**PLANNED UNIT DEVELOPMENT
& SUBDIVISION STAFF REPORT****Date: August 2, 2012**

DEVELOPMENT NAME Heron Lakes Subdivision, Phase One, Resubdivision of Lot 38

CONTEMPLATED USE Planned Unit Development Approval to amend a previously approved Planned Unit Development to allow reduced side-yard setbacks in a proposed single-family subdivision, and Subdivision approval to create 2-lots from existing legal lot of record.

SITE PLAN

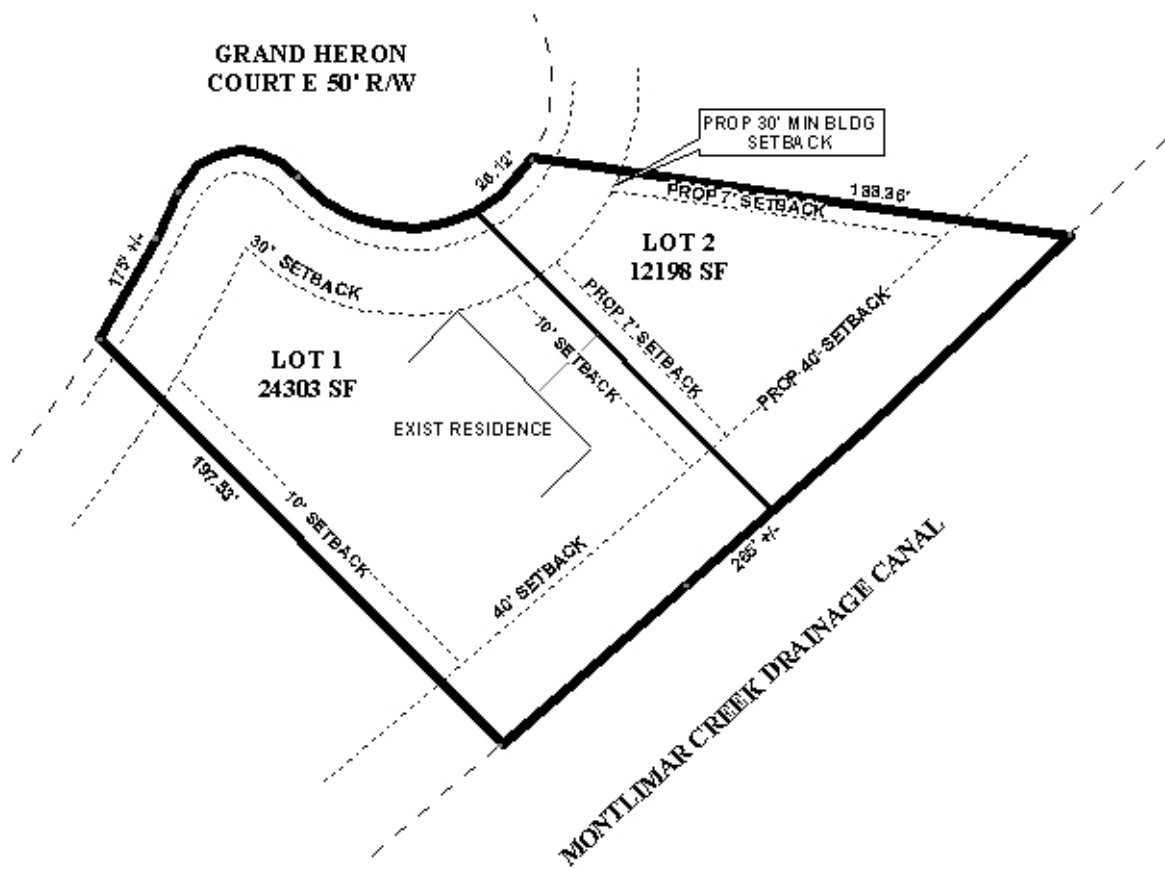
The applicant specifically requests a 30-foot minimum building setback line and 30-foot rear yard setback; however, requests that a 10-foot side yard setback for Lot 1 and 7-foot side yard setbacks for Lot 2. No mention by the applicant of the request for increasing the density requirements for these lots.

It should be noted that in this case the minimum side yard setback allowed on the North side for Lot 2 of this development would be 8-feet, due to the adjacent lot is not included in the amended PUD.

Given the number of such requests and approvals, documentation should again be provided that the existing storm water system is adequate.

The preliminary plat illustrates a 50-foot right-of-way along Grand Heron Way and Grand Heron Court East are minor streets, which comply with the requirements of the Major Street Component of the Comprehensive Master Plan; therefore, no dedication would be required. As access management may be a concern, Lot 1 should be limited to the existing curb cut and Lot 2 should be limited to one curb cut with the size, design and location to be approved by Traffic Engineering and conform to AASHTO standards.

- 1) compliance with Engineering Comments (*provide all of the required information on the Final Plat [i.e. signature blocks, signatures, certification statements, legal description, required notes]*) , to be approved by City Engineering Department prior to signing of the Final Plat;
- 2) the North side yard setback for Lot 2 should be changed to 8-feet and illustrated on the Final Plat;
- 3) the placement of all setbacks for both lots on the Final Plat; and
- 4) lot 1 should be limited to the existing curb cut and Lot 2 should be limited to one curb cut with the size, design and location to be approved by Traffic Engineering and conform to AASHTO standards

- 1) submission of documentation that the existing storm water facilities are adequate to handle the additional lot, to be approved by City Engineering Department prior to signing of the Final Plat;
- 2) the North side yard setback for Lot 2 should be changed to 8-feet and illustrated on the revised PUD site plan;
- 3) the placement of all setbacks for both lots on the revised PUD site plan;
- 4) submission of two copies of the revised PUD site plan to the Urban Development office prior to the signing of the Final Plat; and
- 5) full compliance with all other codes and ordinances.
